**NUMBER:** 08-107-19

Positive Generator Battery Cable location Re-route

This bulletin involves re-routing the position of the positive generator battery cable.

2019 (BV) Jeep Renegade

**Fig. 1**  
**Generator Positive Cable**

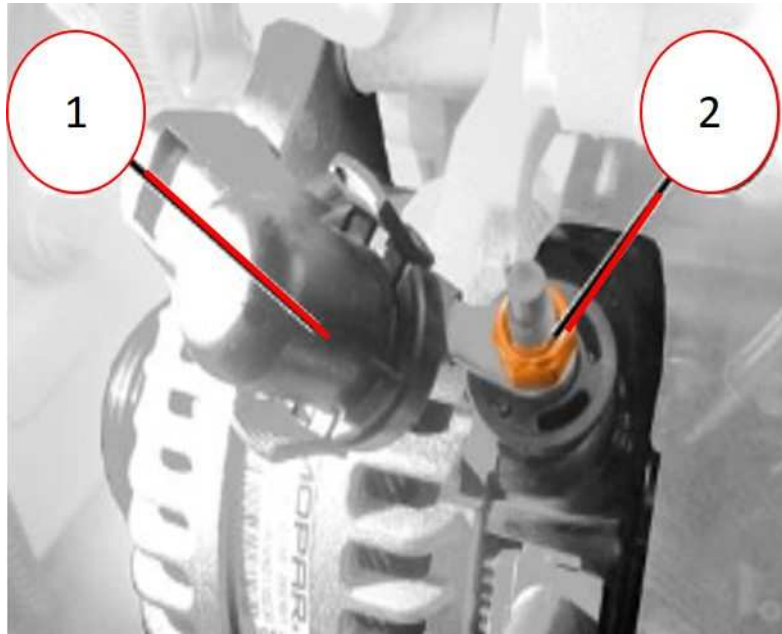
2. Remove the protective cap and remove the nut for the battery positive electrical connection at the generator (Fig. 1) .

4. Connect the positive battery cable to the generator, then tighten the positive battery nut to 15 N·m (133 in.lbs) (Fig. 1) .
5. Connect the negative battery cable. If equipped with an Intelligent Battery Sensor (IBS), connect the IBS connector. Refer to the detailed service procedures available in DealerCONNECT> Service Library under: Service Info> 08 - Electrical / 8F - Engine Systems / Battery System / Cables, Battery / Removal and Installation> Negative Cable.
6. Cycle the ignition ON/OFF/ON.

**Fig. 2**  
**Generator Cable Rerouting Position**

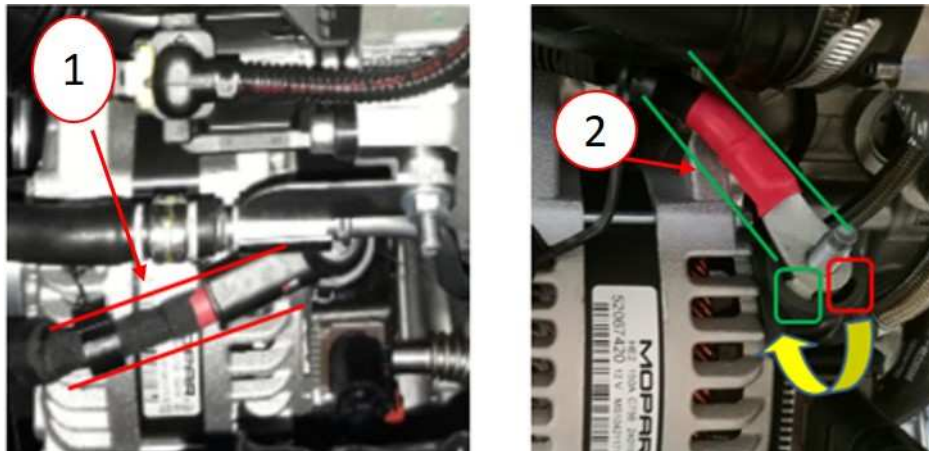
The generator positive battery cable may come into contact with the generator drive belt pulley.

3. Re-route the generator positive cable as shown (Fig. 2) .

- 1 - Before Re-routing.  
1 - After Re-routing.
-
